# Van Waters & Rogers Inc.

June 30, 1994

VAN WATERS & ROGERS INC.  
ICM WORK PLAN

FIGURE 1. SOIL-VAPOR/GRNDWTR  
RECOVERY WELLS

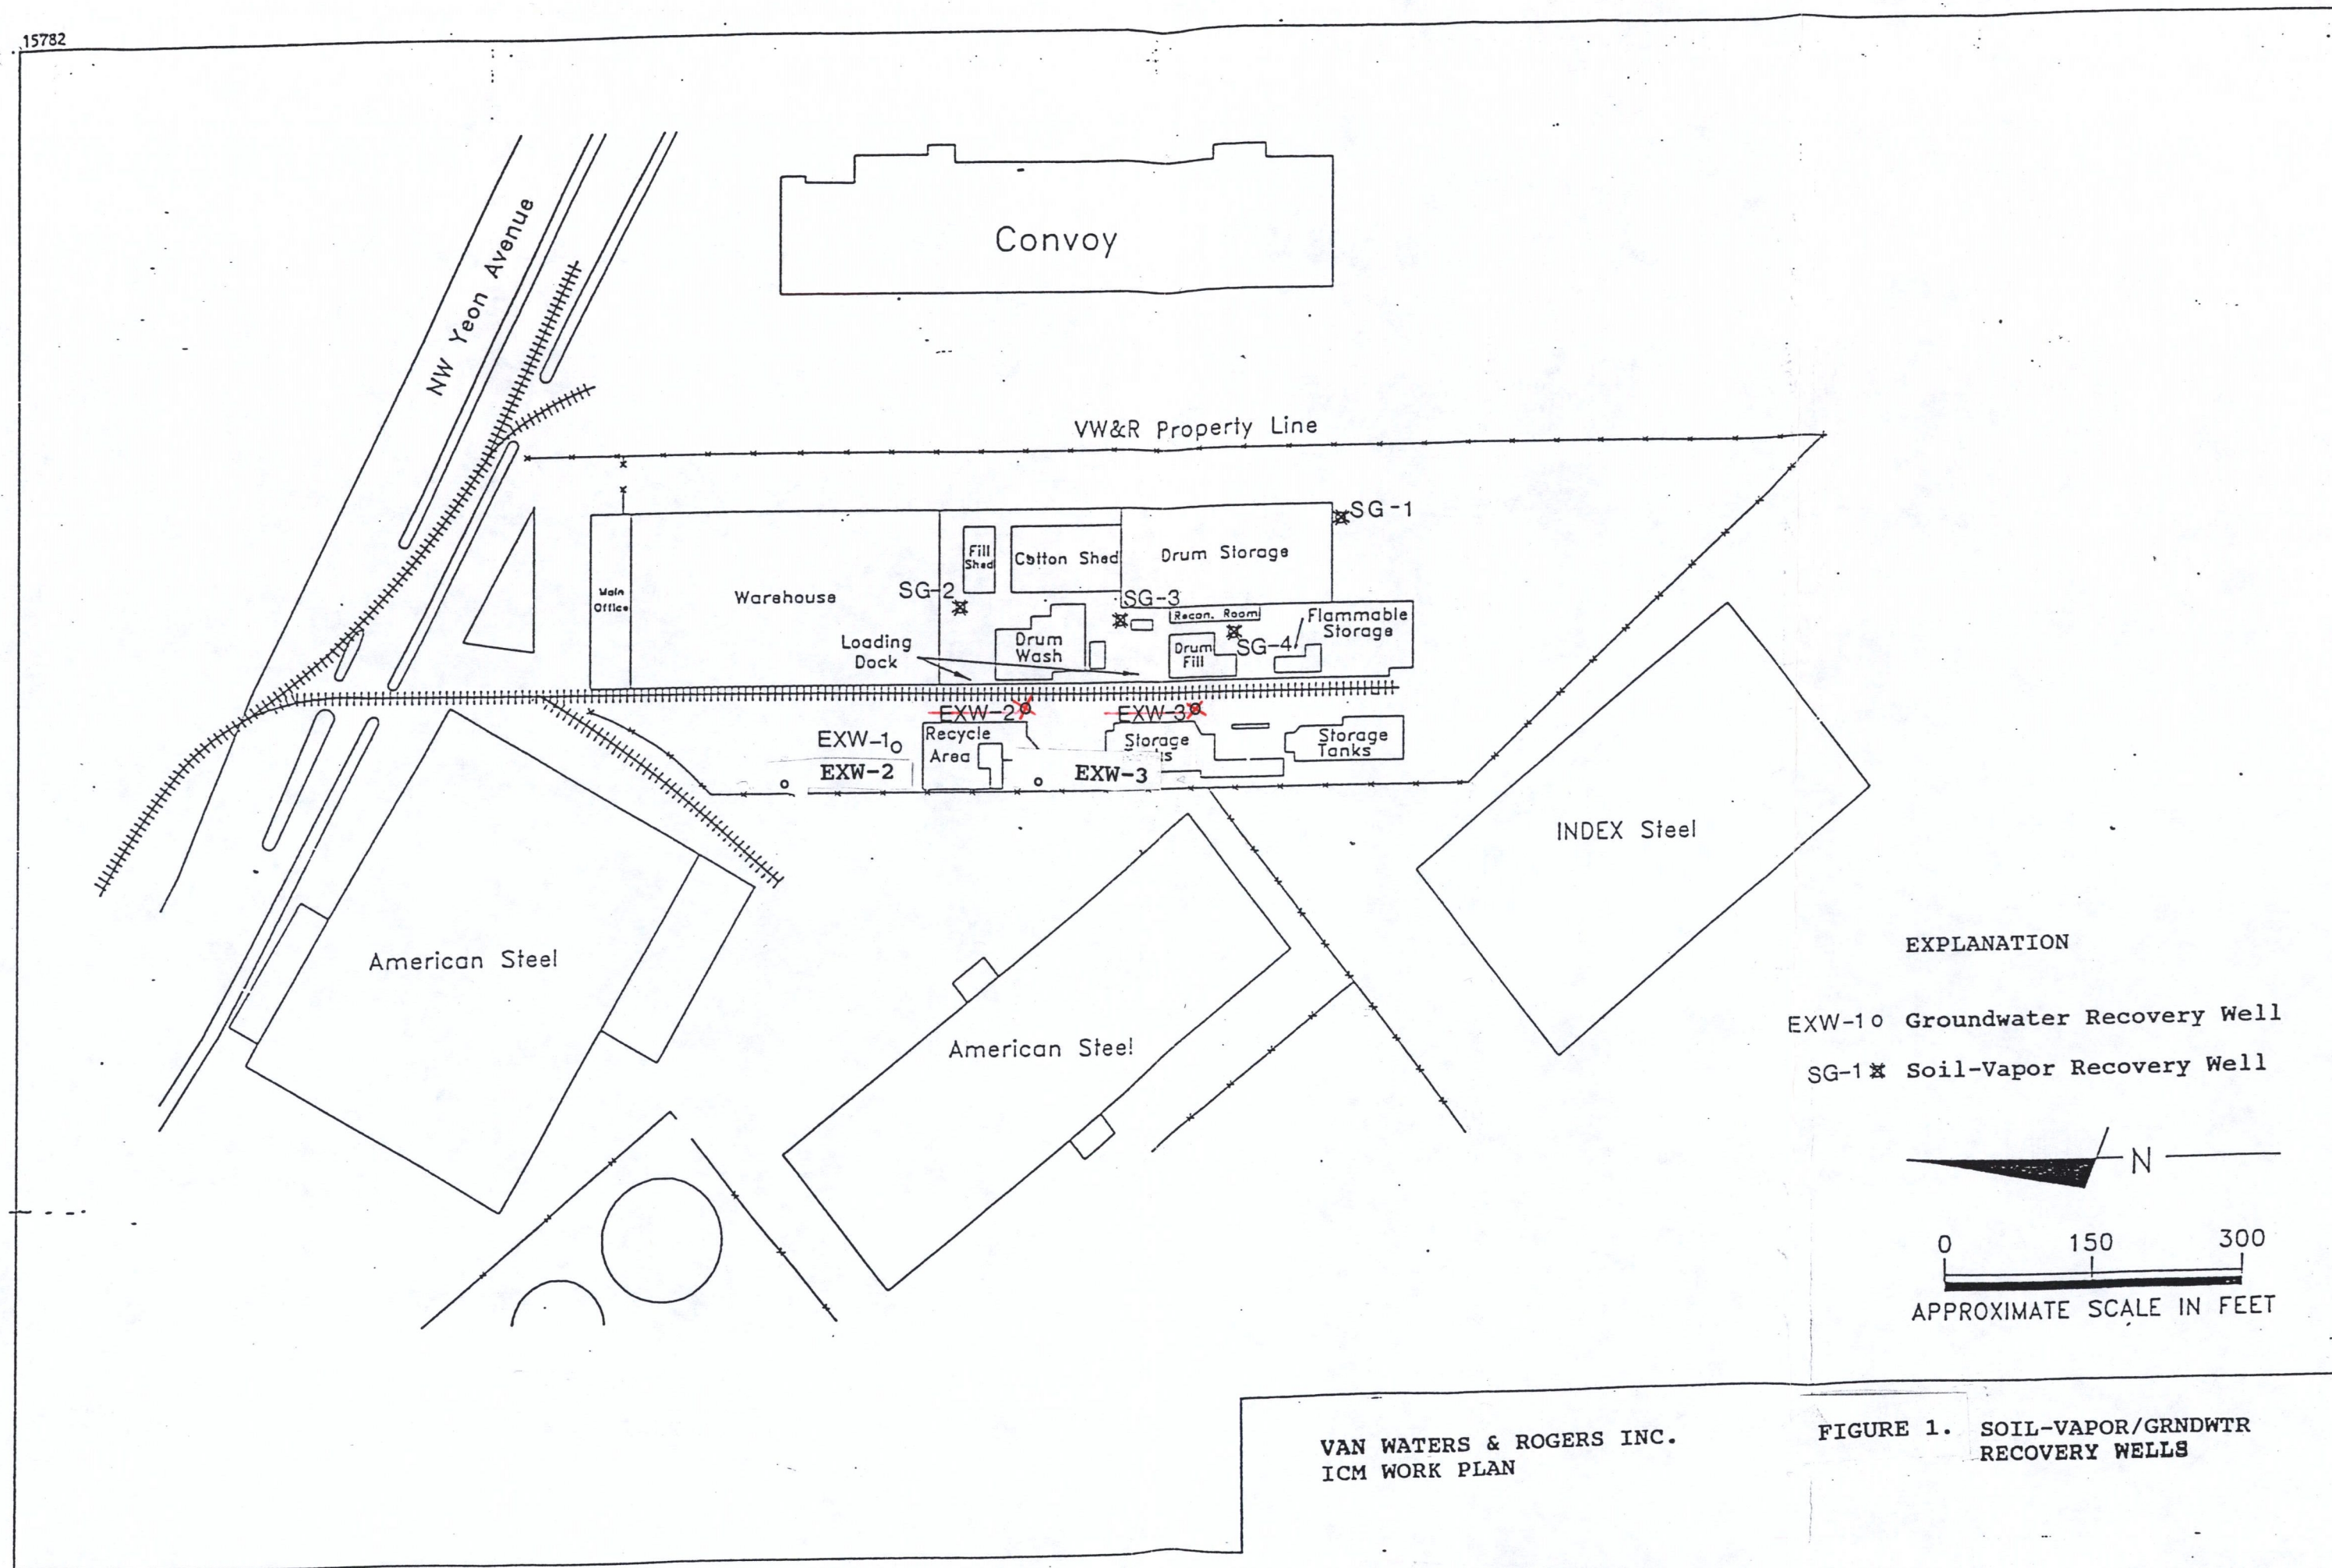
As you are aware, Van Waters and Rogers Inc. (VW&R) is attempting to obtain a discharge permit for treated ground water generated at the Portland, Oregon facility. An NPDES Permit application, formally submitted to the State of Oregon for approval, was rejected over concerns raised by the City of Portland regarding the potential to have elevated levels of ammonia and cyanide in the effluent of the treatment system. It is our belief that this potential can be significantly reduced by locating the extraction wells exclusively along the western fence line. This will require a modification to the ICM work plan since two of the three proposed extraction wells were to be located adjacent to the rail spur, in the vicinity of SMW-6 and SMW-7.

The phased approach for installation of the monitoring wells will remain as stated in the ICM work plan. The first extraction well (EXW-1) has been installed and is expected to commence operation within 45 days of approval of a discharge permit. This well will operate for approximately 90 days before the second phase is implemented. The two remaining ground water extraction wells will be installed in Phase II. It is anticipated that the second well will be operated for a period of 90 to 120 days before the third well is installed. These wells will be placed in areas of ground water contamination along the western fence line. Figure 1 (attached) shows the tentative locations for these wells, however the final locations will be based on the hydrologic parameters and operating performance of EXW-1 and upon the results of the most recent ground water analytical reports.
